LEXINGTON-FAYETTE URBAN COUNTY GOVERNMENT CONTRACT CHANGE ORDER Page 1 of 2	Date:	November 16, 2015
	Project:	Senior Citizen Center Construction
	Location:	Lexington
To (Contractor): Marrillia Design & Construction 259 West Short Street Suite 325 Lexington, KY 40507	Contract No.	227-2014
	Original Contract Amt.	\$8,882,900.00
	Cumulative Amount of Previous Change Orders	\$1,349,994.37
	Percent Change - Previous Change Orders	15.20%
	Total Contract Amount Prior to this Change Order	\$10,232,894.37
	Change Order No.	28

CHANGE ORDER NO. 28

PROJECT	LFUCG Senior Citizens' Center 201333	DATE SENT	10/27/2015
SUBJECT	Entry Drive Subsurface Remediation	PROPOSAL REQUEST ID	PR-040
TYPE	Proposal Request	TRANSMITTAL ID	00713
PURPOSE	For Review and Response	VIA	Info Exchange

**Subject: Limited Exploration and Pavement Subgrade Recommendations
Lexington Senior Citizens Center – Idle Hour
St. Ann Drive
Lexington, Kentucky**

SHEET L6.1 R-1

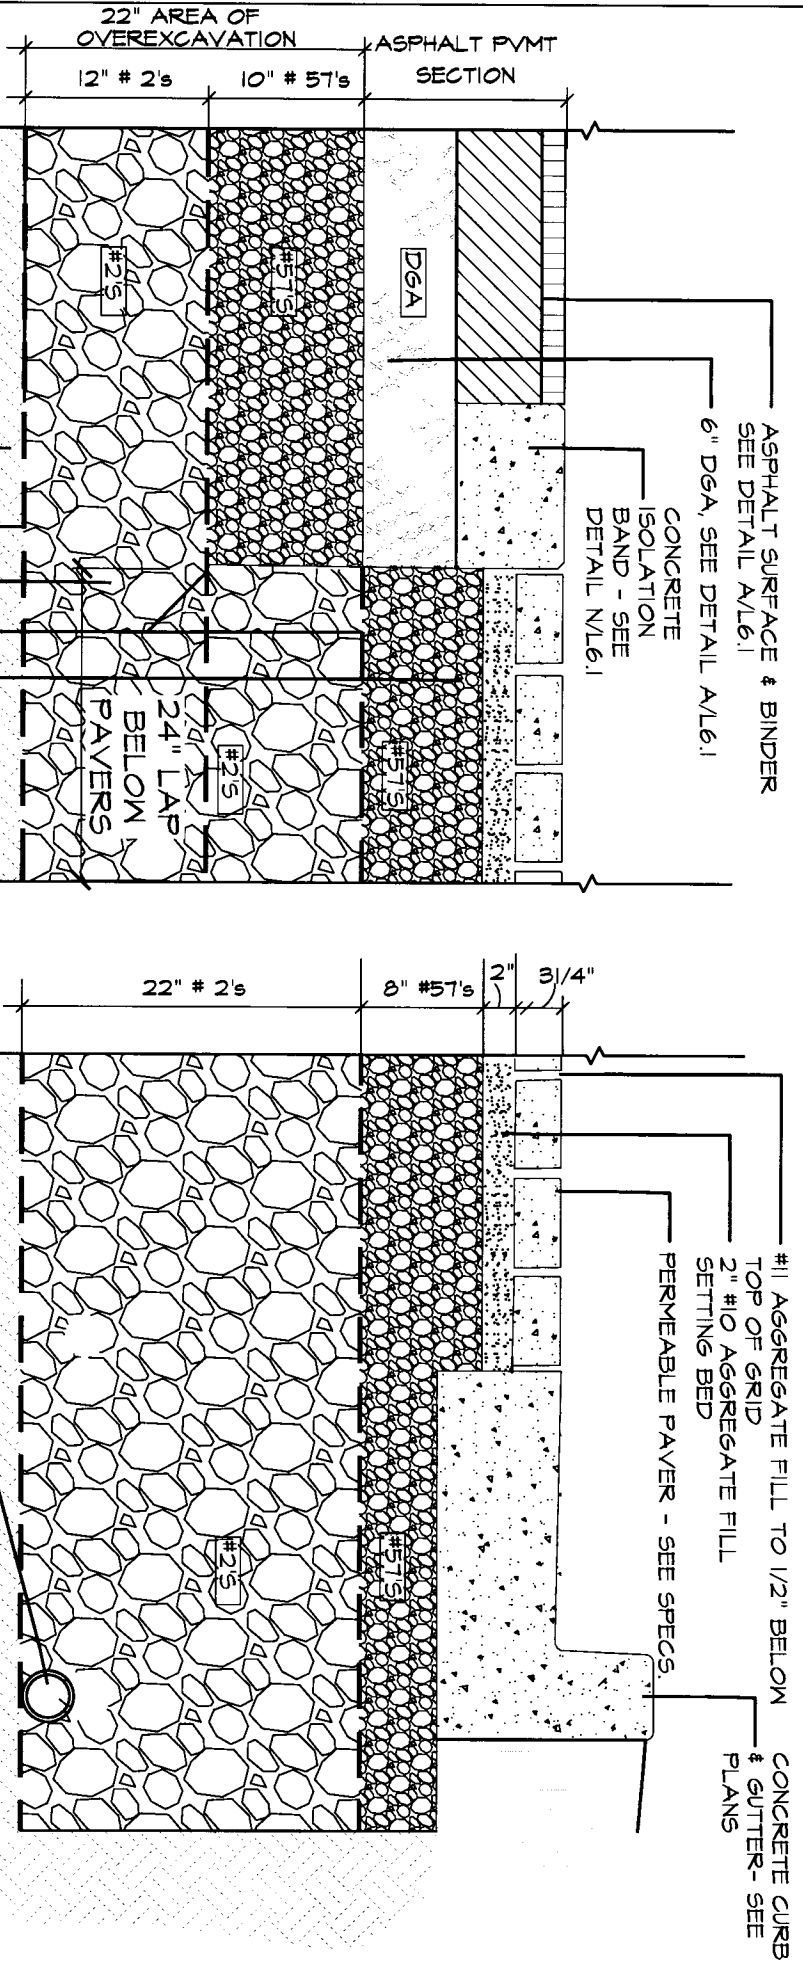
Please provide pricing to remediate the subsurface grades below paving subgrade at the Life Lane entry drive, per recommendations by the geotechnical engineer. Site observation has shown the entire entry drive area designated for heavy duty pavement (per sheet L4.1) is unstable under construction traffic, and the recommendation is as follows:

- undercut below pavement subgrade by 24 inches
- install an 8" perforated pipe at the base of undercut as shown on attached sketch L10.0, drain to structure CI-6
- install stone and geotextile per PR-018 recommendations (similar to those used in main parking areas, see attached sketch)

- install heavy duty asphalt paving (6" DGA, 5 1/2" base course, 1 1/2" surface course) over compacted sub-grade stone per A/L6.1

22" AREA OF OVEREXCAVATION

8" PERFORATED PIPE IN STONE, SLOPE 1/8"/FT

#57 STONE, PLACE IN SINGLE LIFT

GEOTEXTILE, TENSAR BX1200 OR APPROVED EQUAL, CONTINUOUS BETWEEN #2'S AND #57'S

#2 STONE - PLACE IN SINGLE LIFT
MOVEN HIGH PERFORMANCE GEOSYNTHETIC FABRIC, MIRAFI HP570 OR APPROVED EQUAL, CONTINUOUS

SLOPE SUBGRADE 1/8" / FT MINIMUM TO 6" PERFORATED DRAIN TILE AND BEYOND

GRADING & DRAINAGE

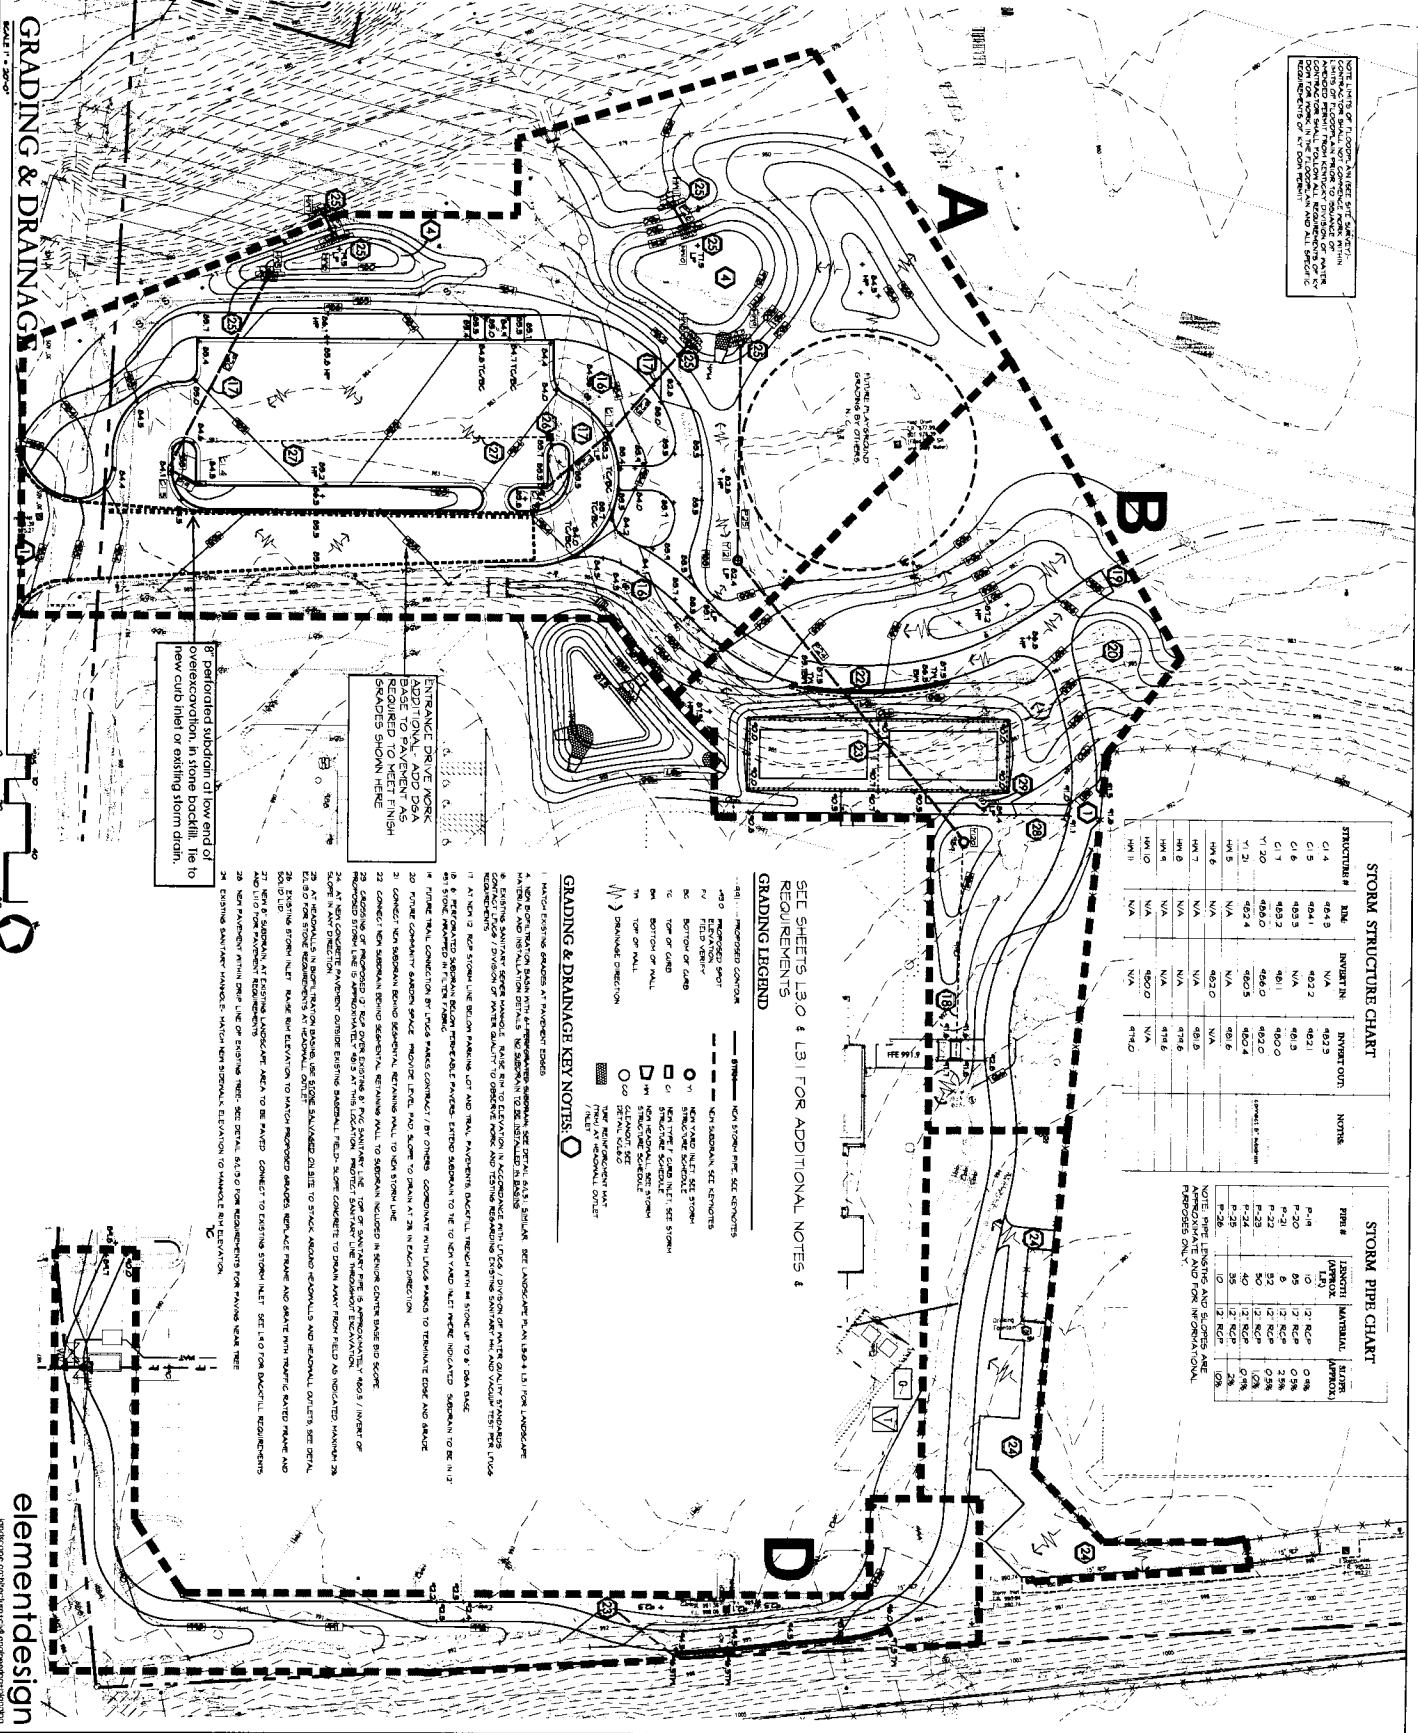
ENTRANCE DRIVE WORK ADDITIONAL. ADD DATA BASE TO PAVEMENT AS SHOWN IN FINISH GRADES SHOWN HERE.

perforated substratum at low end of overexcavation in stone backfill. Tie to new curb inlet or existing storm drain.
